Service Technical Information

MODEL NO. AM-HX50 / HX55
SUBJECT Noise heard on headphones during playback operation

REF.No. :G - A0 - 042 - E0

Main unit OPE LED

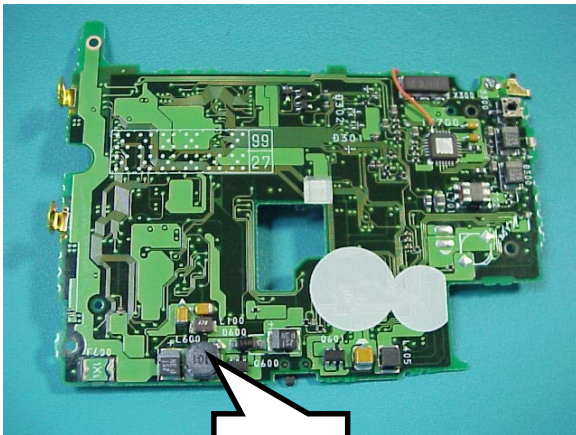
The models concerned may produce low-level noises with volume at minimum position. The noises occur in synchronization with blinks of OPE LED, approximately 8 seconds after starting playback operation. Take the following action against the problem.
